5. The Lady L Ranch; KPB File 2022-123

KPB File No.	2022-123
Plat Committee Meeting:	September 12, 2022
Applicant / Owner:	David and Rebecca Short of Soldotna, Alaska
Surveyor:	John Segesser / Segesser Surveys
General Location:	Jackson Avenue, Kalifornsky

STAFF REPORT

The Lady L Ranch

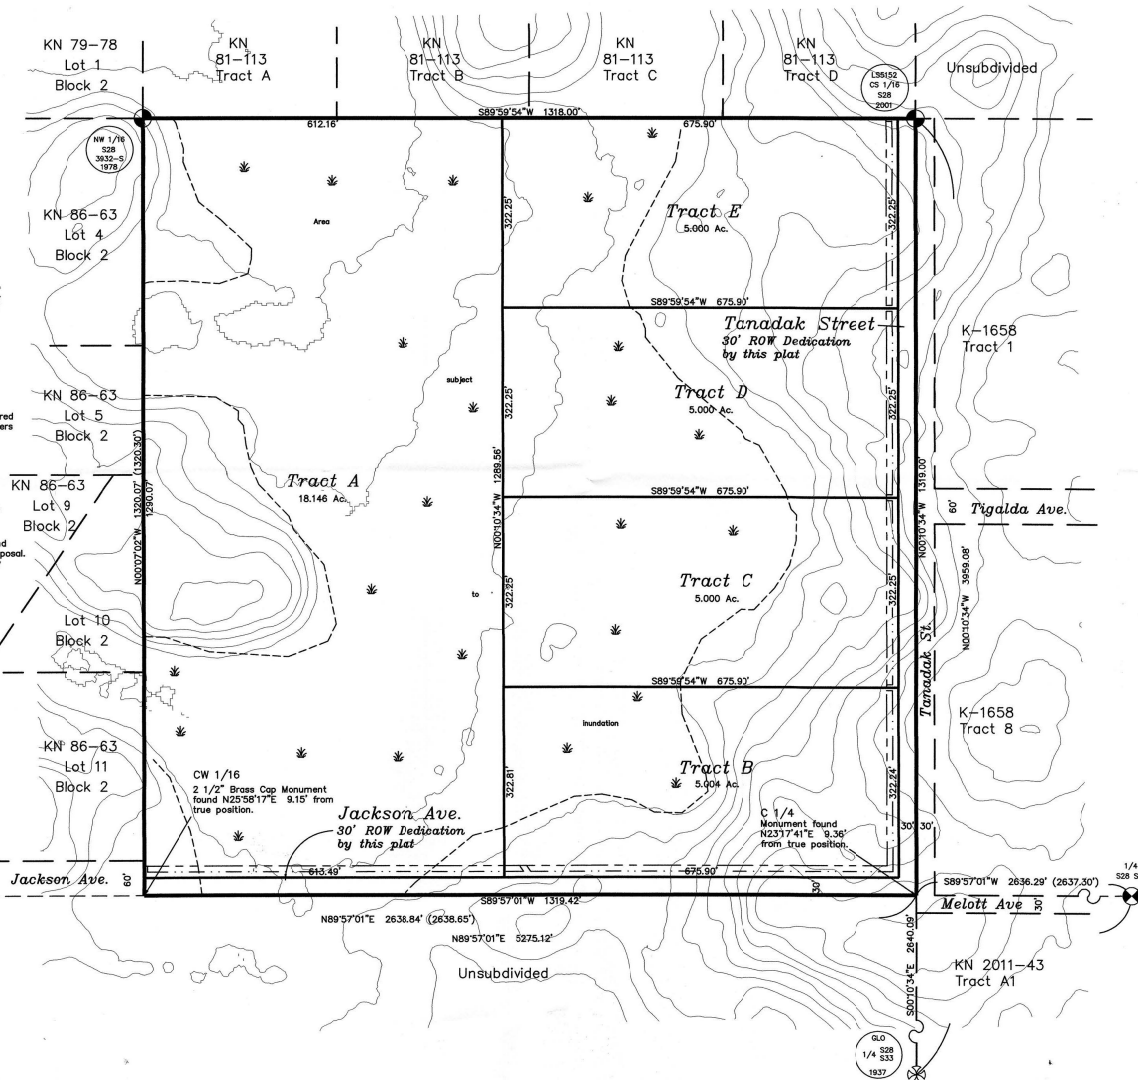
recommends the right-of-way be depicted within the subdivision with a reference label to either a plat note or a label stating “50 foot right-of-way permit, ADL 63002, as found in Book 117 Page 554, KRD.”

Site Investigation: There are low wet areas present in the proposed plat that are depicted. Per KPB GIS imagery, there may be areas with open water. **Staff recommends** the status of the open water be determined and depicted on the plat and label as pond, seasonal pond, etc., and wetlands remain on the final plat.

Slopes are depicted on the plat. There is a solid dotted lines that appear on the plat but it is not labeled or within the legend. **Staff recommends** label the line to indicate what that line represents if it is for the top or toe of bluff that it remain on the final plat.

The slopes within Tanadak Street and Jackson Avenue appear to exceed allowable slopes for rights-of-way. **Staff recommends** the surveyor verify the slopes are compliant and if they exceed allowable slopes provide centerline profiles and cross-section analysis to determine if additional widths or slope easements are required.

There is a current house on Tract B with a driveway starting in the southwest corner coming off Jackson Avenue. The driveway runs along the south through Tracts A and B and the dedication of Jackson Avenue. As stated within the legal access discussion, staff recommends the right-of-way dedication encompass as much of the existing right-of-way as possible and be 60 feet wide on the western portion and reduce down to 30 feet wide on the eastern portion. **Staff recommends** the location of the structure will need to be verified to ensure it is not within the dedication, if the structure will be within the 20 foot setback or 10 foot utility easement, the building will need to be depicted on the final plat with plat notes added that it predates the creation of the setback and/or utility easement.

there will be more than 40,000 square feet of upland area. **Staff recommends** the overall acreage and upland acreage for each lot be labeled on the final.

Utility Easements The parcel within this subdivision has not had a plat done and thus no utility easement granted by plat exist. The plat is proposing a 10 foot utility easement along the dedicated rights-of-way that increases to 20 feet within 5 feet of the side lot lines. **Staff recommends** the depiction of the utility easement between Tract A and Tract B be adjusted.

- Provide Basis of Bearing
- Plat note 3 needs to be changed to 3 from 4.
- Add distance and bearing to line to west at southwest corner of plat

- Staff recommendation:** *Check acreage, not sure total is 40.000 acres*
- D. A vicinity map, drawn to scale showing location of proposed subdivision, north arrow if different from plat orientation, township and range, section lines, roads, political boundaries, and prominent natural and manmade features, such as shorelines or streams;

- Staff recommendation:** *Rex's Road was renamed to Tote Road to the intersection with Leisure Lake Dr. Update the label.*
- G. The status of adjacent lands within 100 feet of the proposed subdivision boundary or the land status across from any dedicated rights-of-way that adjoin the propose subdivision boundary, including names of subdivisions, lot lines, block numbers, lot numbers, rights-of-way; or an indication that the adjacent land is not subdivided;

- Staff recommendation:** *Lot 10 on the west, add the subdivision notation, update Tract C to the north to Lot 2 from Plat KN 2001-65.*

- Staff recommendation:** *Review the slopes within the proposed dedications and provide centerline profiles and cross-sections if they do not comply to determine if additional width or slope easements are required.*

- Staff recommendation** *Start the right-of-way dedication of Jackson Avenue on the west side at the 60' point as is shown for the dedication from Hideaway Heaven. Continue east across plat to a point that is 30 feet north and 30 feet west of the southeast corner of the property; also, being the intersection point for Tanadak Street and Jackson Avenue, this will pick up some of the existing drive/road on the west side of the dedication.*

- Include the reference to KPB Code in plat note 4, "(KPB 14.06)".
- Add plat notes if the structure is within the setback and utility easement.
